REMARKS

The present invention concerns a hose device which is intended to be coupled onto a tubular member and has a channel which presents a non-circular cross-sectional shape when unmounted and a circular cross-sectional internal shape when mounted. Such a configuration compensates for the flexibility but incompressibility of the flexible material from which the hose device is constructed. Here, the inventor has recognized that the prior art elastic hose devices may result in a restriction of the flow area when the hose device is mounted to a tubular connection member introduced into the hose device. The inventor has addressed this problem by amending the internal cross-sectional shape. According to the prior art, the internal cross-sectional shape is circular which would be the natural approach to mounting a hose onto a circular tubular member. Here, the inventor has developed a superior hose device by deviating from such a circular internal cross-sectional shape. By this invention, it is possible to achieve a hose device which, after being mounted onto a tubular connection member, the internal cross-section is circular, and thus has a maximum flow area. In order to more clearl

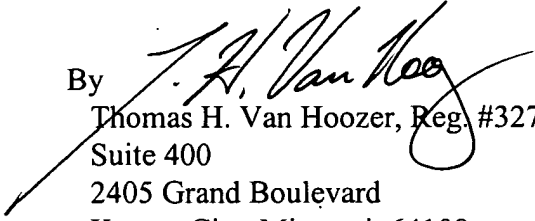
In the Office Action, the Examiner has required corrections to the drawings, and a new Fig. 5 is submitted herewith in response to those requirements with respect to the cross-sectioning of the tubular member and the reference character "α". In addition, the examiner objected to the drawing because reference sign "a" is not mentioned in the specification. Applicant courteously invites the Examiner's attention to page 8, line 22 where the reference character "a" is discussed, and thus this ground of rejection is respectfully traversed. Applicant also advises that when the original Swedish priority application was translated, the word "after" was omitted in the sentence at page 9, lines 27-29 of the PCT application in English. This error has now been corrected and the specification amended accordingly herewith.
